## Sri Venkateswara Temple Façade Updates JSP08-08

Consideration of the request of Manyan Group LLC for revised Preliminary Site Plan and Section 9 Façade Waiver. The subject property is located in Section 16 on the west side of Taft Road between Grand River Avenue and Eleven Mile Road in the RA, Residential Acreage District. The applicant is proposing to modify the approved facades and install a 'temporary façade' in place of the 'permanent façade' for a limited period of time.

## PLAN REVIEW CENTER REPORT

Re: **FACADE ORDINANCE REVIEW**  
**Sri Venkateswara Temple - Facade Revision, SP# ZCM12-0008**  
 Façade Region: 1, Zoning District: RA

**EAST ELEVATION**  
 SCALE: 1/8" = 1'-0"

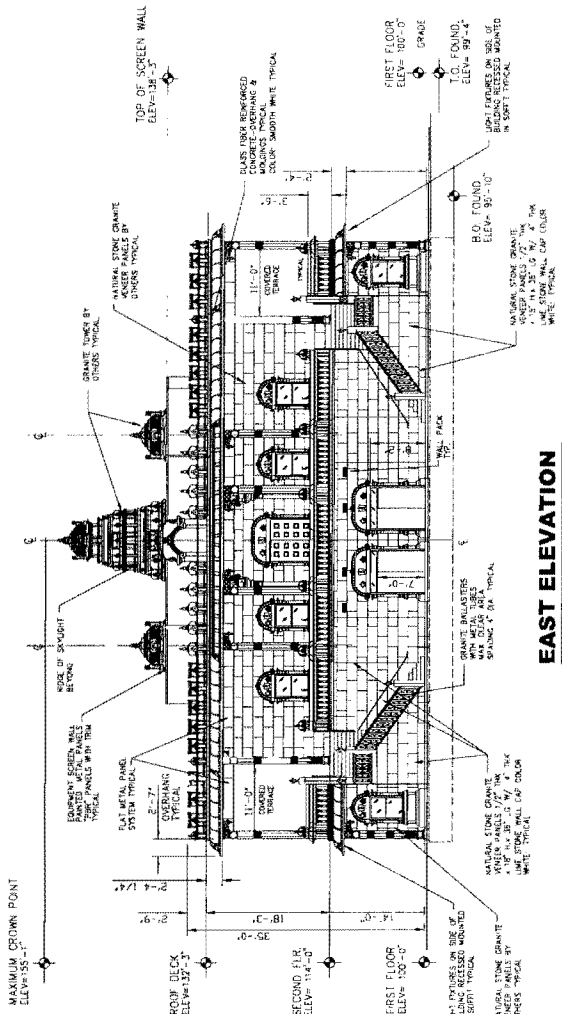
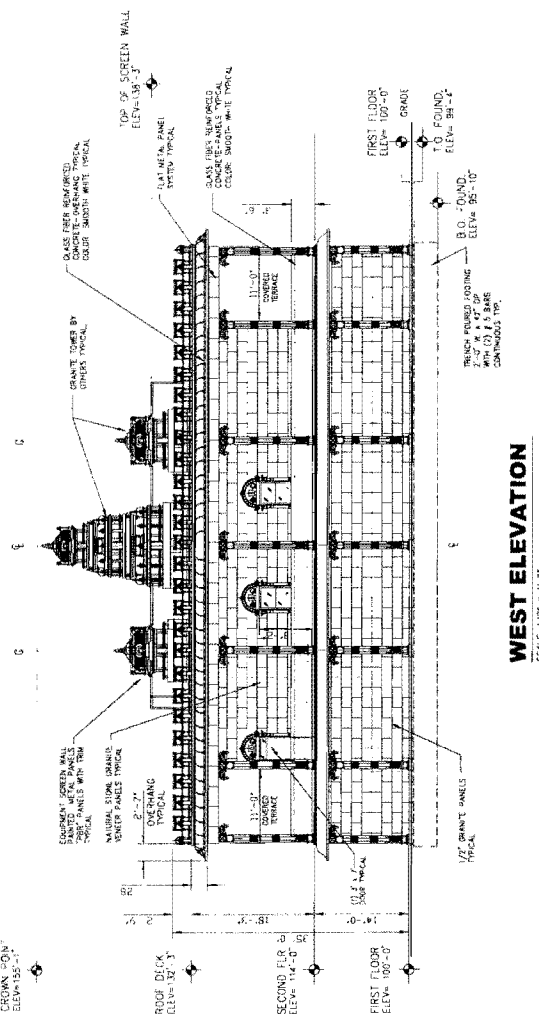
<b>Current Façade 5/11/11</b>	East (Front)	West (Rear)	North (Right)	South (left)	Ordinance Maximum (Minimum)
Brick (Alaska White Velour)	35%	45%	<b>20%</b>	<b>20%</b>	100% (30%)
Glass Fiber Reinforced Concrete (GFRC)	25%	<b>30%</b>	25%	25%	25%
Granite Veneer Panels	40%	25%	<b>55%</b>	<b>55%</b>	50%

<b>Revised Façade 4/16/12</b>	East (Front)	West (Rear)	North (Right)	South (left)	Ordinance Maximum (Minimum)
Brick (Alaska White Velour)	<b>0%</b>	<b>0%</b>	<b>0%</b>	<b>0%</b>	100% (30%)
Glass Fiber Reinforced Concrete (GFRC)	25%	<b>30%</b>	25%	25%	25%
Granite Veneer Panels	<b>75%</b>	<b>70%</b>	<b>75%</b>	<b>75%</b>	50%

As shown above the revised façades does not comply with the Façade Ordinance. The minimum percentage of Brick (30%) is not provided on all facades, the percentage of GFRC exceeds the Ordinance maximum on the west façade, and the percentage of Granite Panels exceed the Ordinance maximum on all facades.

The applicant has stated in his cover letter that he believes the use Granite Panels in lieu of brick will achieve a “more homogeneous approach” that will better compliment the building and create a more authentic Temple. We are in full agreement. In this case the proposed Granite Panels are of equal or better aesthetic value to the originally proposed (white) brick. We would be interested to see the proposed color of the GFRC to assure that a carefully coordinated color match with the Granite Panels is achieved.

**Recommendation:** It is our recommendation that the revised design is consistent with the intent and purpose of the Façade Ordinance. Additionally, the revised façades are consistent with Section 9 Waivers previously given and therefore qualify for administrative approval. This recommendation is contingent upon the applicant providing a revised sample board illustrating a carefully coordinated color match between the Granite Panels, GFRC, and other materials.
